Final Mitigated Negative Declaration/Initial Study, SCH 2023040473

This document constitutes the Final Initial Study / Mitigated Negative Declaration (IS/MND) for the Camino Pablo Single-Family Residential Subdivision, Rezone, General Plan Amendment, and Development Plan that consists of Major Subdivision application CDS23-09646, Rezone application CDRZ23-03270, General Plan Amendment application CDGP21-00004, and Development Plan application CDDP23-03012, to allow development of the southern 7.9 acres of the 23.9-acre project site consisting of a residential subdivision of 13 single-family residences with attached accessory dwelling units (ADUs) incorporated into 11 of the residences. The remaining northern 16.0 acres of the site would remain as agricultural open space.

Figure AQ-1: Planning Healthy Places (East Bay Area)

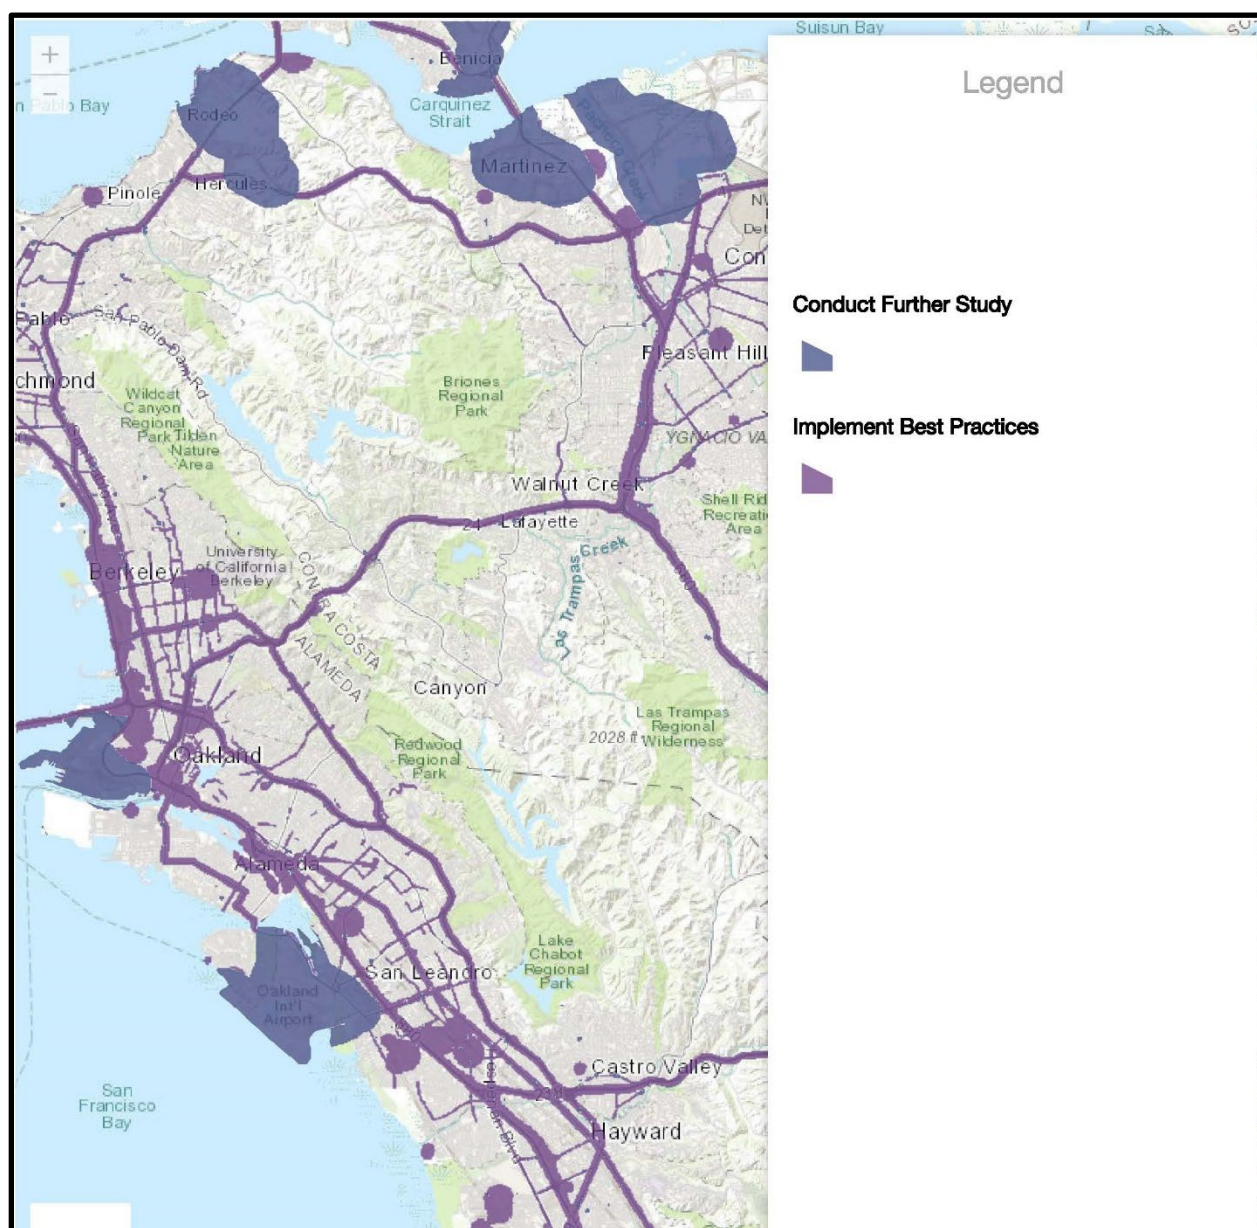
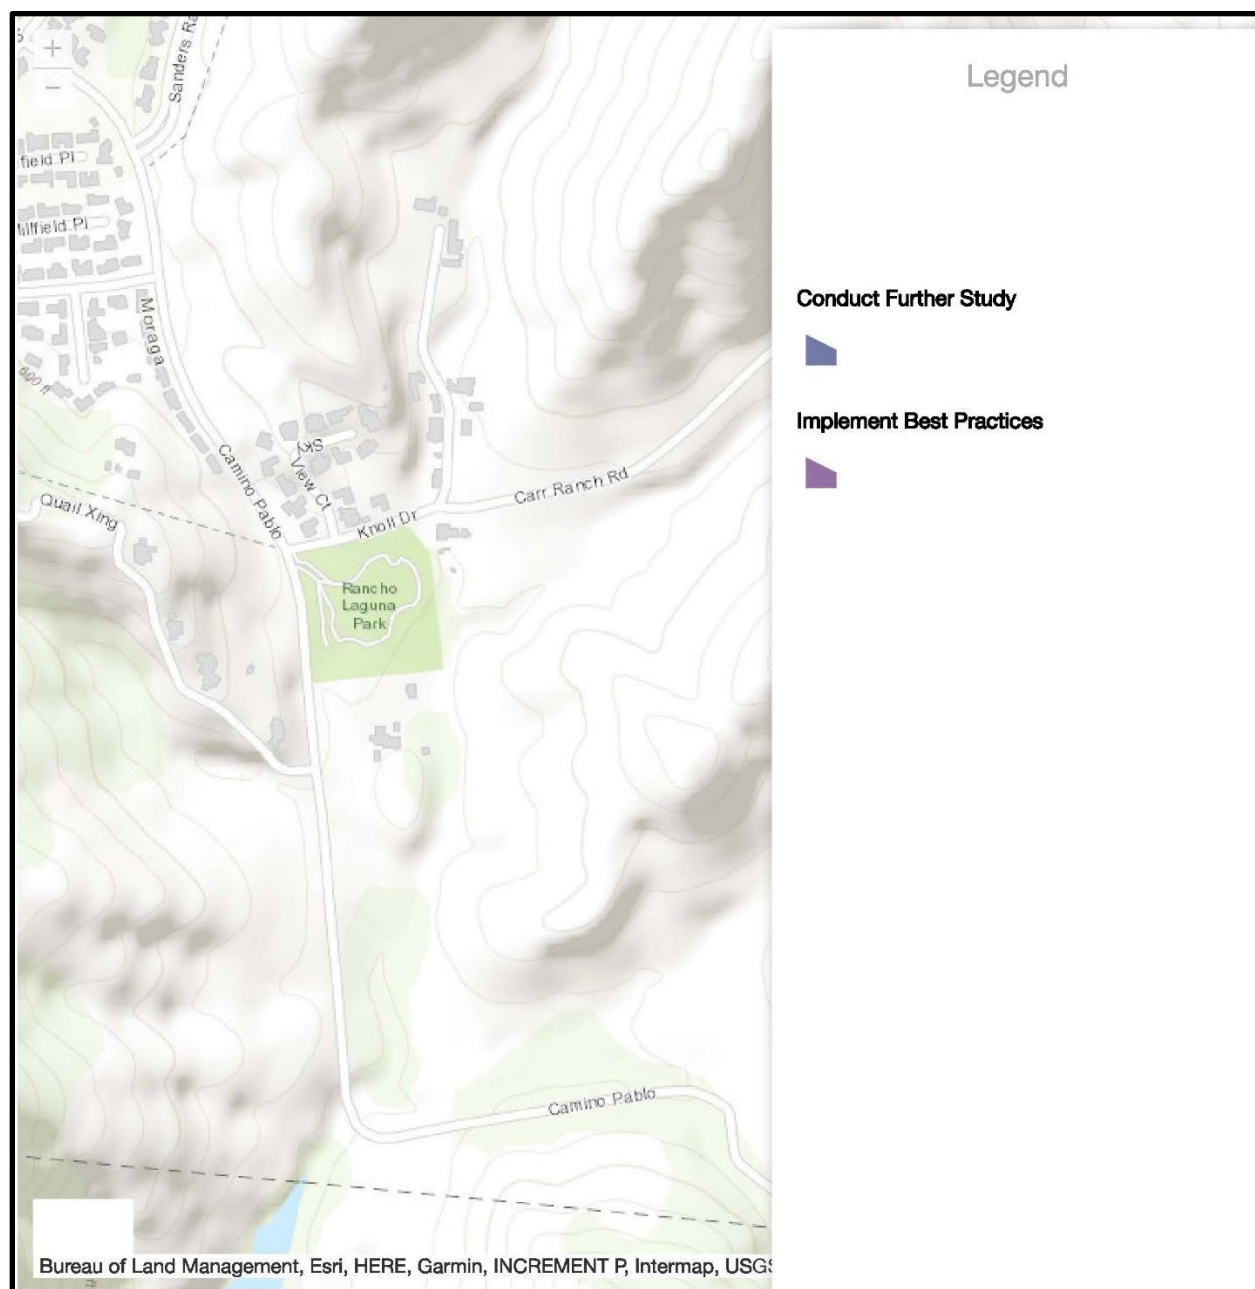
Comment 2.c/2.f/2.h/2.o: The Draft IS/MND improperly conducts analysis regarding project impacts on sensitive receptors. Specifically, the commenter opines that the document lacks sufficient analysis of potential project impacts to high-risk high-sensitivity receptors. There is inadequate basis for the IS/MND conclusion of "less than significant" air quality impacts, particularly those potentially affecting sensitive receptors.

Comment 2.i: The Draft IS/MND does not include critical analysis or mitigation of the substantial nuisance and other effects to existing sensitive receptors within the immediate project vicinity.

Response: The comment asserts that the analyses of impacts specifically exclude sensitive receptors, did not identify the receptors, or address the harm that would result from the project. The noise, air quality, and health risk analyses presented in the Initial Study were particularly focused on sensitive receptors. The health risk assessment discussed on pages 16-17 of the Initial Study explicitly identify sensitive receptors as the key considerations in the analysis. The thresholds of significance adopted by the Bay Area Air Quality Management District and which served as the basis for the air quality analysis also factor in exposure of all residents, including sensitive receptors. Similarly, the noise analysis calculated anticipated noise levels during project construction at the nearest sensitive residential receptors, and the impact analysis and mitigation requirements were based on noise exposure of these residents. The comment asserts that the analyses summarized in the Initial Study were improperly conducted but does not provide any examples or evidence to support this assertion.

BAAQMD's *Planning Healthy Places: A Guidebook for Addressing Local Sources of Air Pollutants in Community Planning*⁶ was published to support and promote infill development; which is important to reducing vehicle miles traveled and the associated air emissions, while minimizing air pollution exposure for existing and future residents. The *Guidebook* also provides developers and planners with the information and tools needed to create health-protective communities.

health risks to the greatest extent. The *Guidebook* also lists examples of a variety of strategies to reduce exposure to, and emissions of, air pollution, including the adoption of air quality-specific ordinances, standard conditions of approval, and incorporation of policies into general plans and other planning documents. The BAAQMD recommends implementing all best practices to reduce exposure that are feasible and applicable to a project in areas that are likely to experience elevated levels of air pollution. To reduce exposure to pollutants, the *Guidebook* recommends practices like installing indoor air filtration systems, planting dense vegetation, implementing project design which provides a buffer between sensitive receptors and emission sources, and developing alternative truck routes.

Local Responsibility Area Fire Hazard Severity Zones

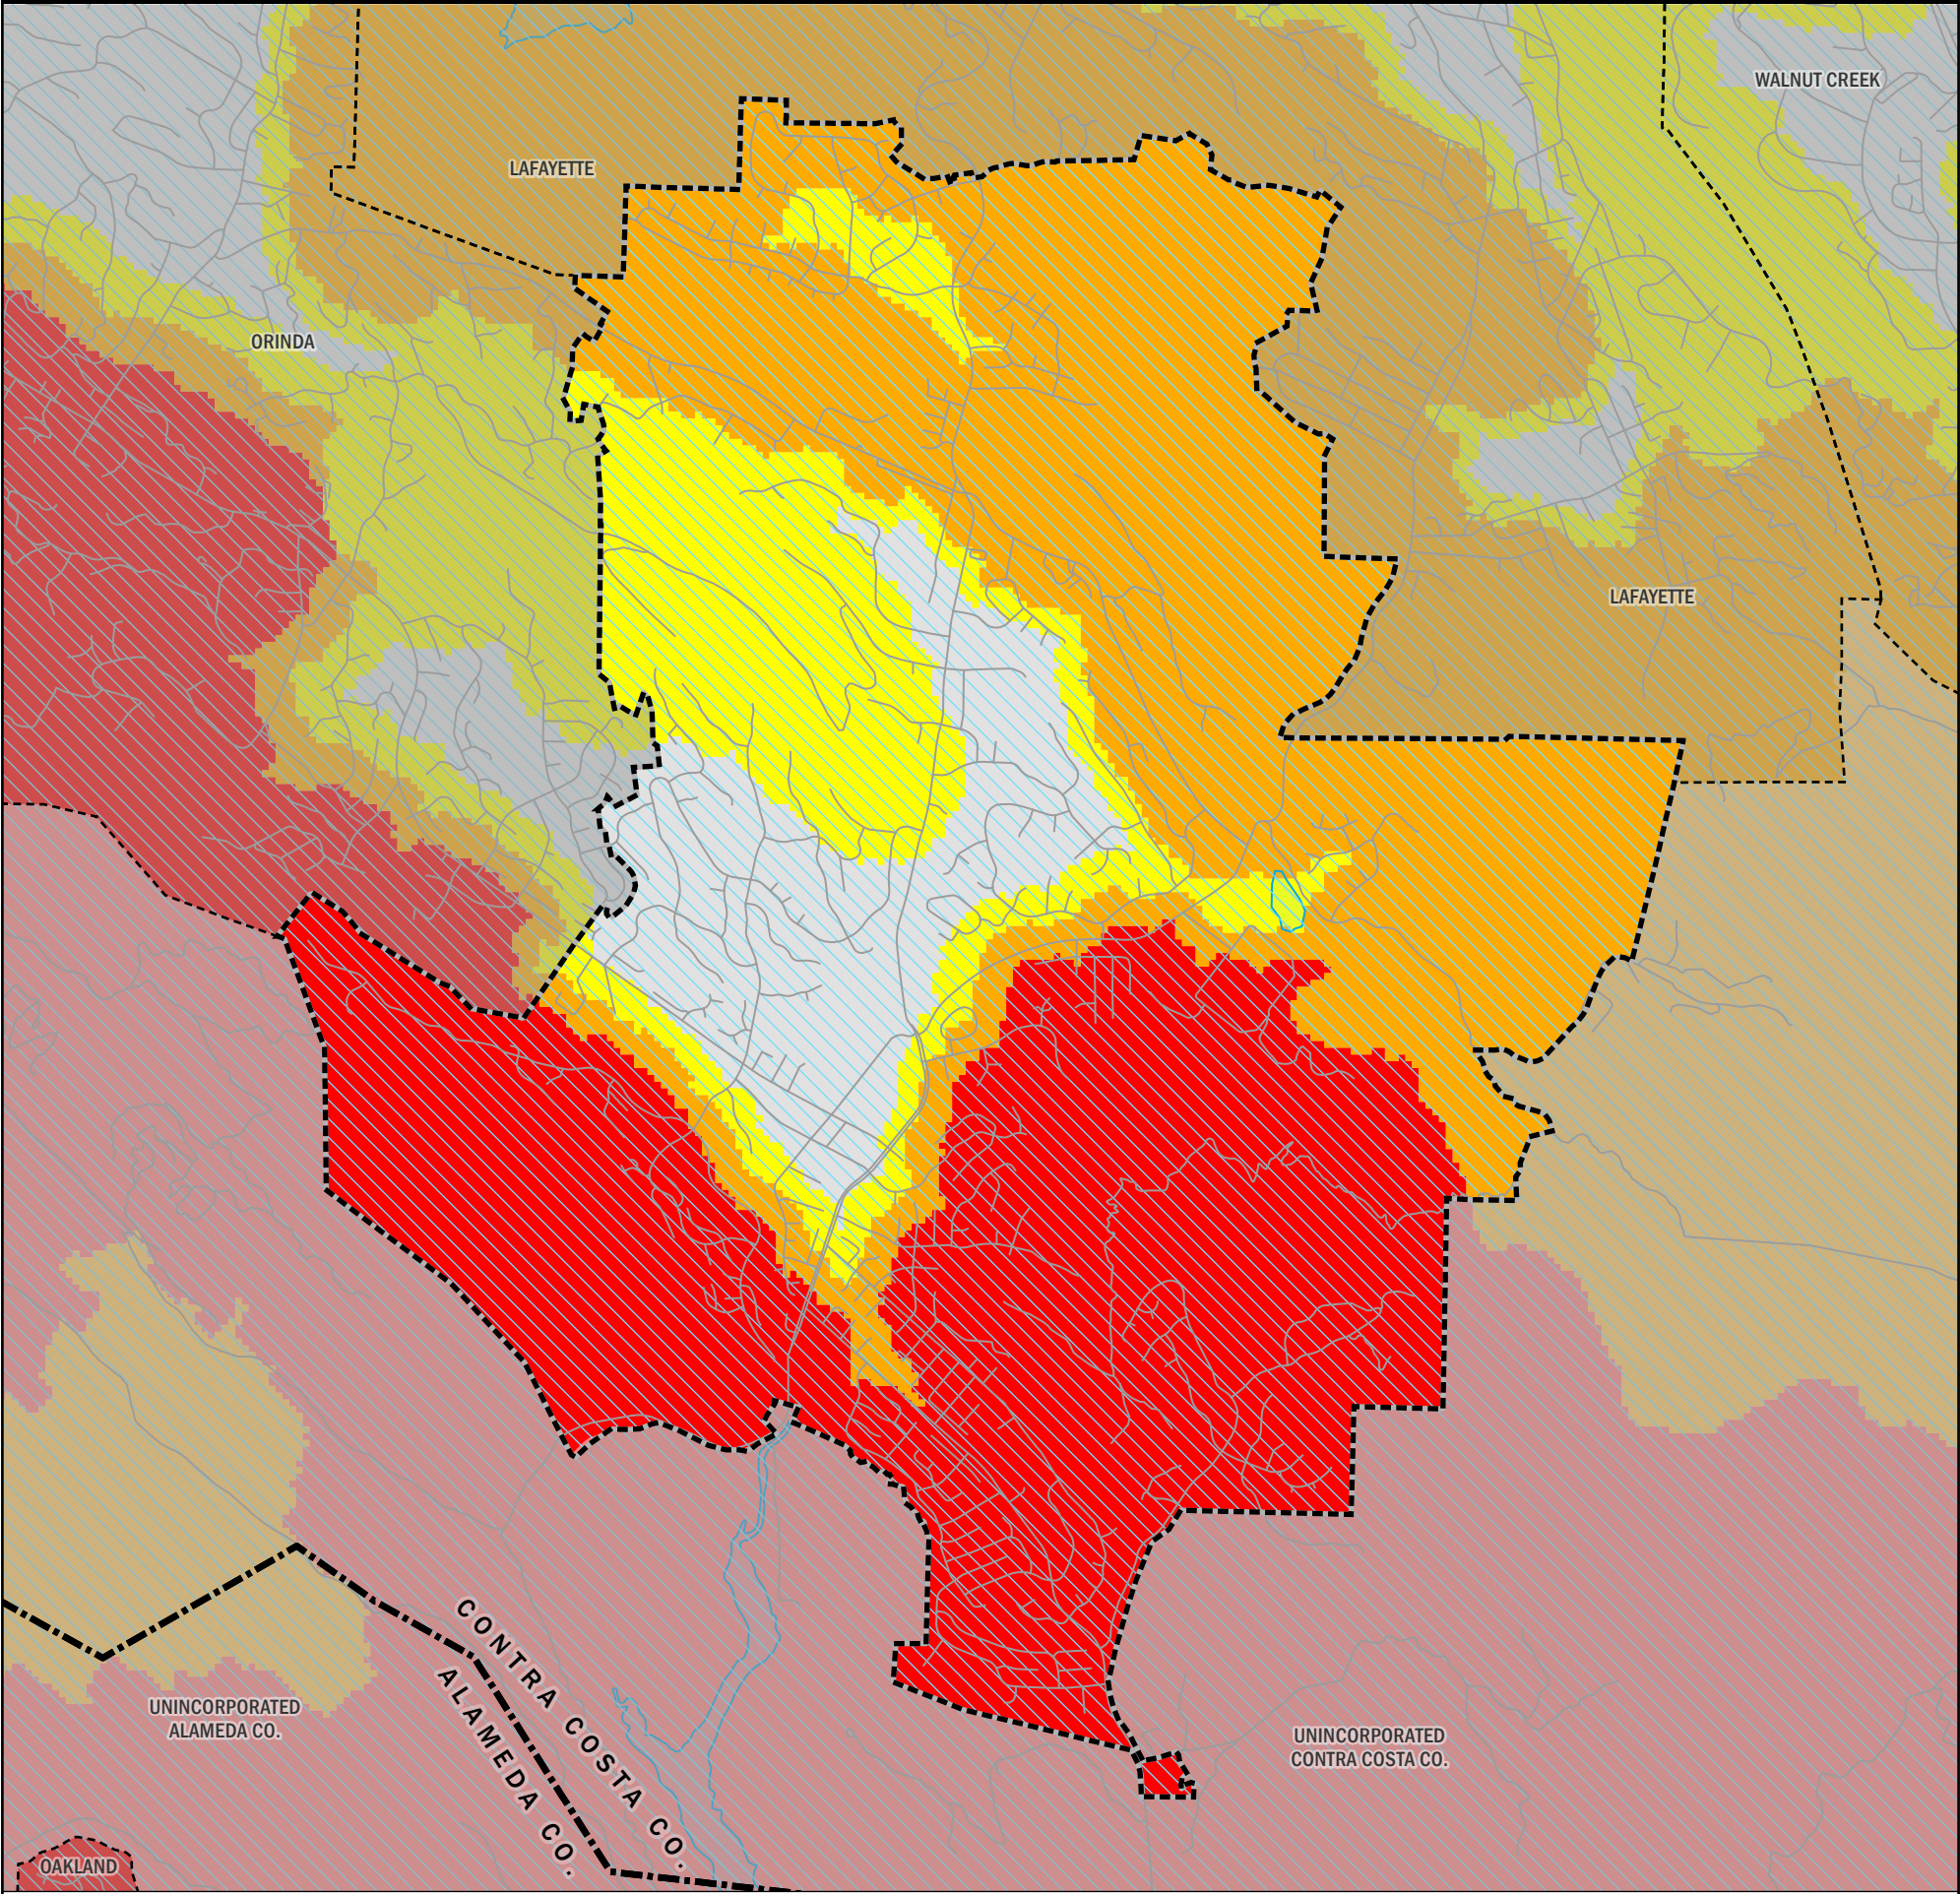
The Project may not be approved at all because it is inconsistent with the General Plan. As discussed above, The Project is inconsistent with the County's General Plan, Health and Safety Element, HS-P7.1, which flatly prohibits new residential development in Very High Fire Severity Zones. Since the Project is proposed to be constructed in a VHFSZ, it is inconsistent with the General Plan.

County staff contends that the Project is "grandfathered in" because at the time that the Project application was initially "deemed complete," the Project site was a High Fire Severity Zone, not a Very High Fire Severity Zone. However, staff ignores the fact that General Plan Policy HS-P7.1 states that the County must "Discourage such projects in High Fire Hazard Severity Zones." Thus, even in Very High Fire Zones, the County has discretion to deny Project approval.

Response: Pursuant to the California Subdivision Map Act, section 66474.2, “the local agency shall apply only those ordinances, policies, and standards in effect at the date the local agency has determined the application is complete”. The project was deemed complete on October 2, 2023, over a year before the adoption of policy HS-P7.1. Therefore, this policy shall not constitute a basis for denial of the project pursuant to the Subdivision Map Act. Also, see responses to comments 19.r (Wildfire) and 19.x (Public Services).
